UNITED STATES PATENT AND TRADEMARK OFFICE

Office Action Summary

10/734,030

DETAILED ACTION

FIG-2

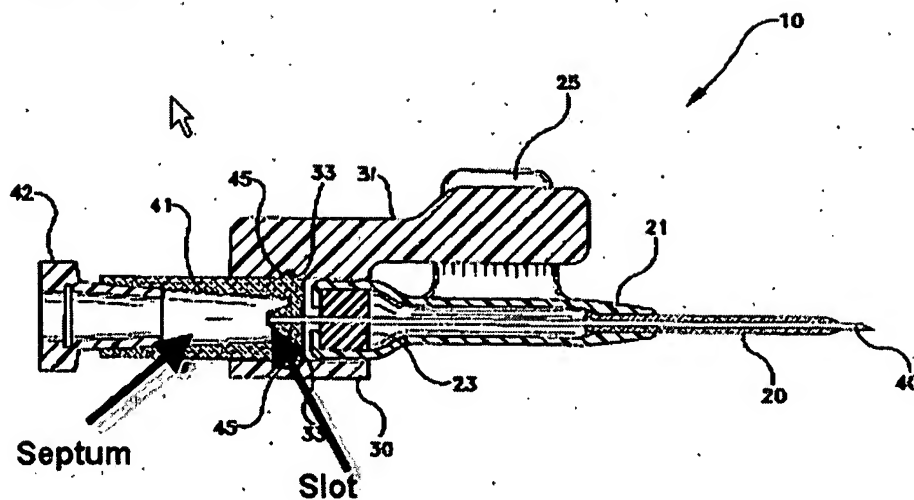
Brimhall '656 discloses a septum and needle assembly comprising: a needle 40 having a proximal end and a distal end; a housing; and septum (Fig. 2) disposed in the housing; wherein the needle is sliding disposed within the septum. A slit is disposed within the septum and the needle is sliding disposed within the slit (claim 2). A tube 50 attached to and in fluid communication with the housing (claim 3); a female adapter 51 attached to the tube (claim 4). Brimhall '656 does not disclose the needle defines a notch adjacent to the distal end.

Brimhall '554 discloses that a needle 16 having a notch 19 located adjacent to the distal end. Therefore, it would have been obvious at the time the invention was made to a person having ordinary skill in the art to modify the device of Brimhall '656 with an opening (notch like opening 19), as taught by Brimhall '554 in order to permit fluid to flow from lumen into annular space.
